To: T10 Technical Committee
From: Robert Sheffield, Intel (robert.l.sheffield@intel.com)
Date: 26 May 2005
Subject: 05-224r0 SAS-1.1: Clarify STP exceptions to SATA link protocol

The rules requiring a SAS phy in an STP connection to handle receipt of a SATA_CONT after a continued primitive sequence has already begun are misplaced in the standard and it is not clearly identified that it is an exception to the general stipulation that frame transmission during an STP connection is governed by ATA/ATAPI-7.

This proposal is to move subclause 7.2.2.4 to subclause under 7.17 STP link layer, and to add text to 7.17.1 to clearly identify which elements of STP protocol represent exceptions to the ATA/ATAPI-7 link layer requirements that apply to SAS ports during an STP connection.

~~Figure 125 — Transmitting a continued primitive sequence~~

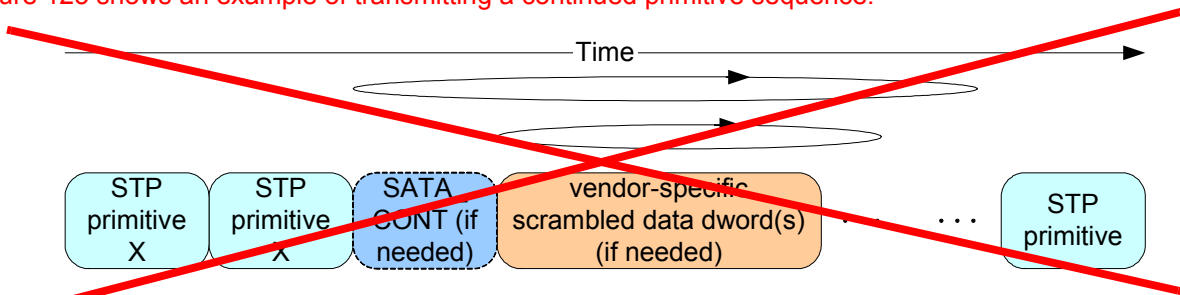
Primitives that form continued primitive sequences (e.g., SATA_HOLD) shall be transmitted two times, then be followed by SATA_CONT, if needed, then be followed by vendor-specific scrambled data dwords, if needed. ALIGNs and NOTIFYs may be sent inside continued primitive sequences as described in 7.2.4.1. [Specific requirements for SATA_CONT are described in 7.17.2.](#) ~~After the SATA_CONT, during the vendor-specific-scrambled data dwords:~~

- ~~a) a SATA_CONT continues the continued primitive sequence; and~~
- ~~b) any other STP primitive, including the primitive that is being continued, ends the continued primitive sequence.~~

~~Figure 125 shows an example of transmitting a continued primitive sequence.~~

~~Receivers shall detect a continued primitive sequence after at least one primitive is received. The primitive may be followed by one or more of the same primitive. The primitive may be followed by one or more SATA_CONTs, each of which may be followed by vendor-specific data dwords. Receivers shall ignore invalid dwords before, during, or after the SATA_CONT(s). Receivers do not count the number of times the continued primitive, the SATA_CONTs, or the vendor-specific data dwords are received (i.e., receivers are simply in the state of receiving the primitive).~~

~~Expanders forwarding dwords may or may not detect an incoming sequence of the same primitive and convert it into a continued primitive sequence.~~

Figure 152 — Transmitting a continued primitive sequence

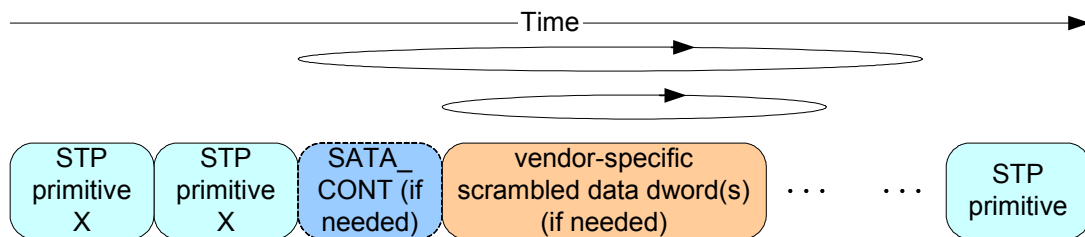
7.17.2 Continued primitive sequence

Primitives that form continued primitive sequences (e.g., SATA_HOLD) shall be transmitted two times, then be followed by SATA_CONT, if needed, then be followed by vendor-specific scrambled data dwords, if needed. ALIGNs and NOTIFYs may be sent inside continued primitive sequences as described in 7.2.4.1. After the SATA_CONT, during the vendor-specific scrambled data dwords:

- a) a SATA_CONT continues the continued primitive sequence; and
- b) any other STP primitive, including the primitive that is being continued, ends the continued primitive sequence.

Figure 152 shows an example of transmitting a continued primitive sequence.

Figure 153 — Receiving a continued primitive sequence

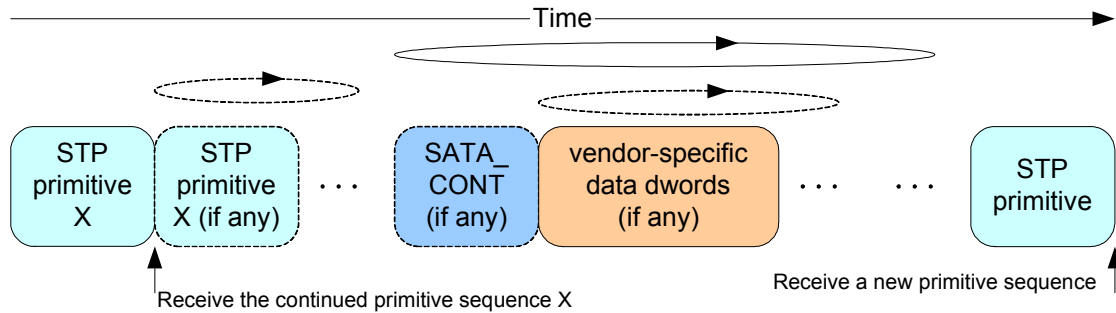
[Figure 153 shows an example of receiving a continued primitive sequence.](#)
